CS Memorandum No. 1443

Subject: Configuration Management Board Meeting No. 126

CMB Meeting Minutes #126

SUBJECT: Configuration Management Board Meeting # 126 – Rev. No. 0

\\s:\s\003\muni\slines\org\mst44\1\moldesign\trains\821\3-structure\building_protection\sheet_files\653\454423BP-24.dwg (mrc) Thu Jan 27 2011 3:40 pm BP-124

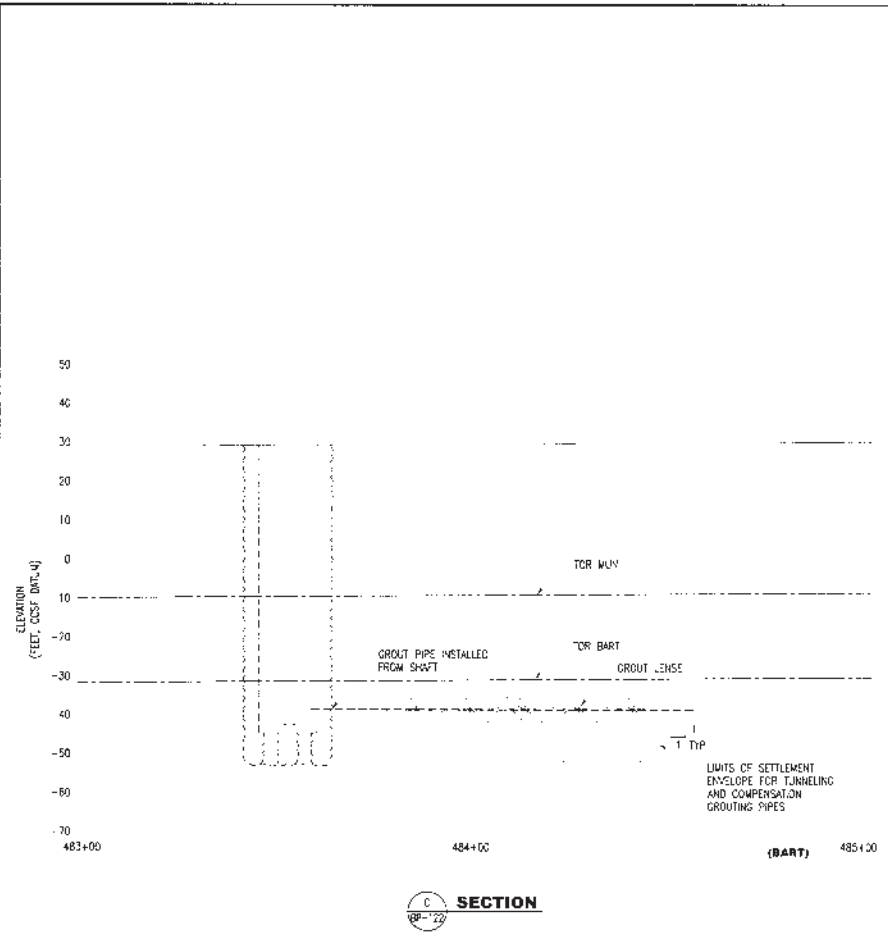
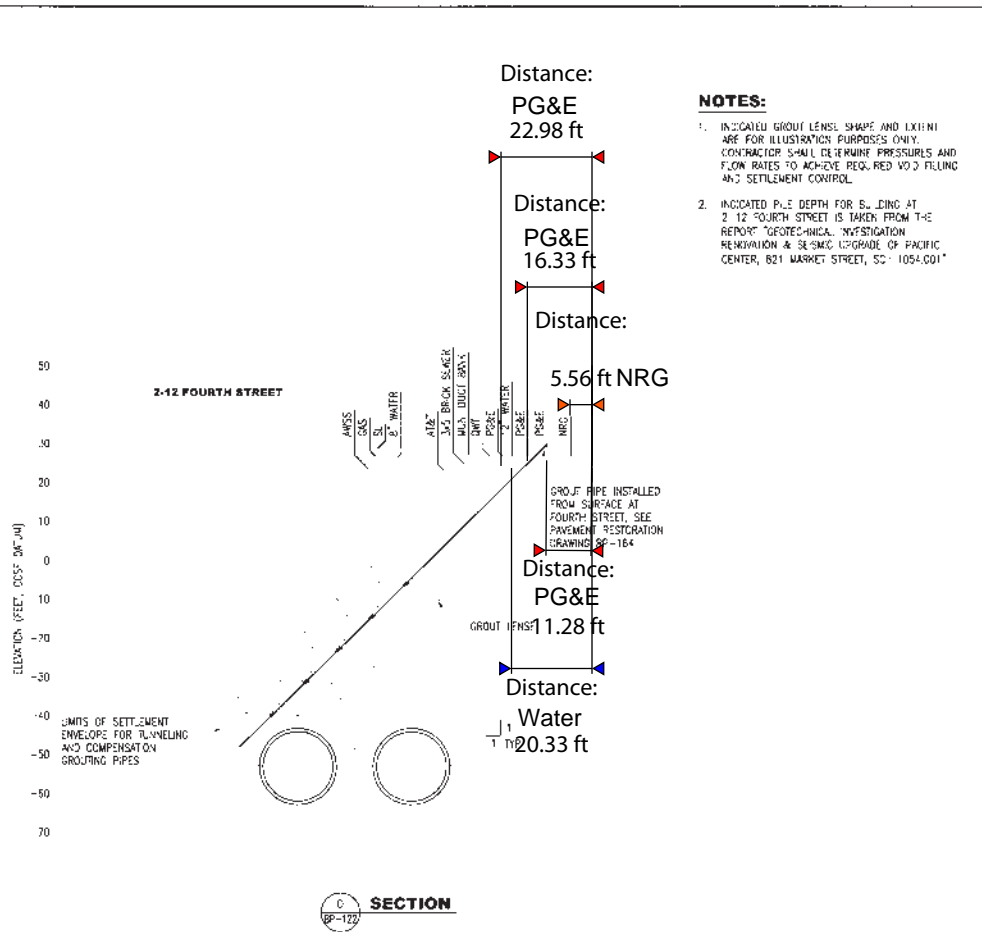
GENERAL	
Proposed Change Sponsor: <u>M. Benson</u>	Received by CMB: <u>05/15/2013</u> (Date)
Affected Disciplines: <u>Building Protection</u>	
Impacts of Change <u>Compensation Grouting – Old Navy - (Inefficiencies)</u>	
Change Order Request (COR 079) Amount Not To Exceed \$152,000

AS-BID CONFIGURATION

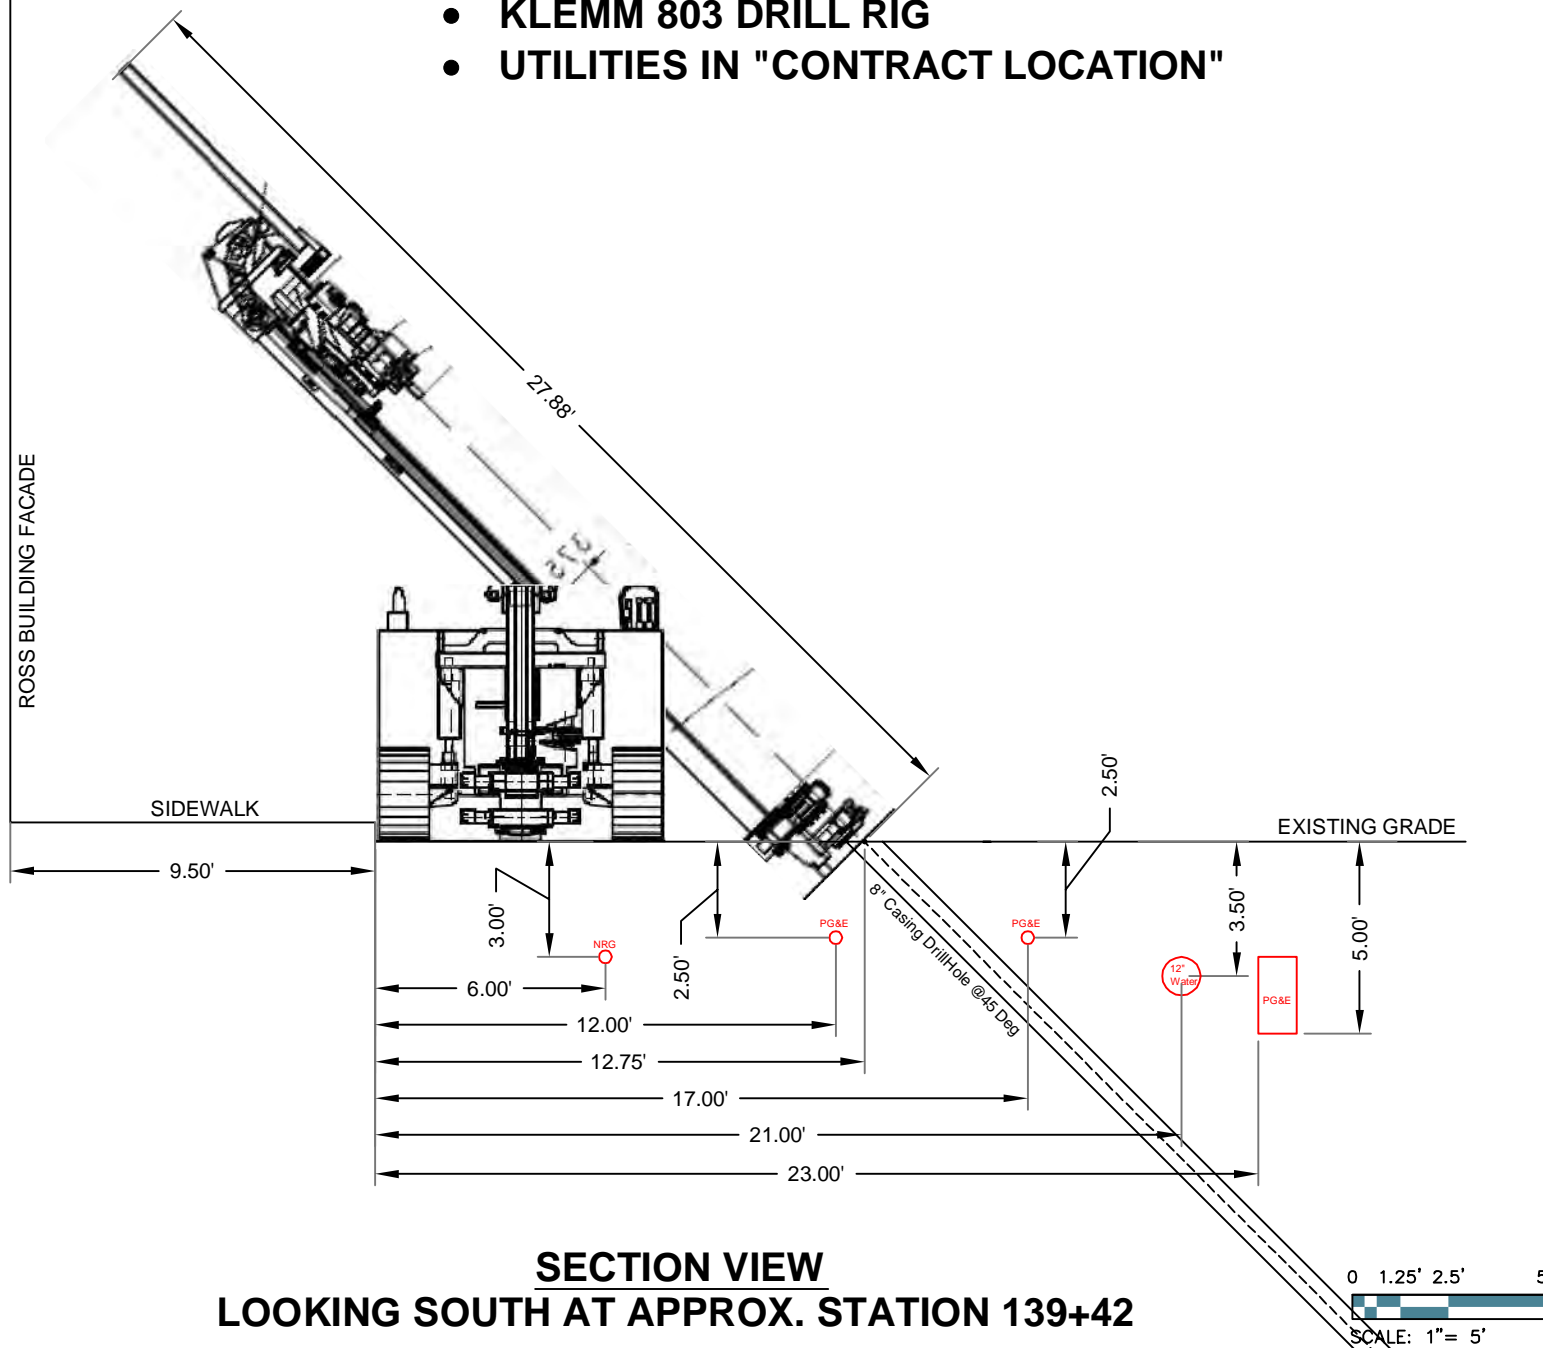
<p>2- 05/08/13</p>	<p>1252 – M. Benson requested approval for negotiation position for COR79 Compensation Grout – Old Navy additional cost associated with inefficiencies of installing the compensation grout tubes. Justification was based on the premise that the larger piece of equipment could have performed the work if the in place utilities had been found as shown in the Bid documents. Because of the actual configuration of underground utilities was much different than that shown on the Bid documents, payment is warranted for the inefficiencies caused by utilizing the smaller piece of equipment. The CMB raised several questions about the graphical depiction of the As Bid condition and requested that the graphical representation be properly updated to show the As Bid condition. Similarly, the actual condition graphic could be improved to better show actual conditions found. Detailed information demonstrating the cost of the inefficiency appear in order, however the requested NTE amount was not properly justified compared to the computed cost by the Engineer. The CMB was unable to provide approval due to the still open question that the utility obstructions potentially indicate the Contractor should have brought in a smaller rig to begin with. CMB suggested improved graphics and supporting information be developed to justify the requested negotiating position. This item will be brought back to the CMB next week. <i>Status: 05/15 A revised graphic was shown depicting the actual condition shown found incorporating the second PG&E 12" electrical line. Further determination from the BP dwgs indicates the Contractor could have actually accomplished the work by using the original larger Klemm machine as listed in the bid proposal. AGREE – CMB 0117 Not to exceed value of \$152,000 to be negotiated as a lump sum for inefficiencies associated with having to use a smaller drill rig to work around the existing utilities. In addition the CM Team will obtain the invoice from the Contractor to identify the actual cost for the rental of the smaller Comacchio drill rig.</i></p>

- KLEMM 803 DRILL RIG
- UTILITIES IN "CONTRACT LOCATION"
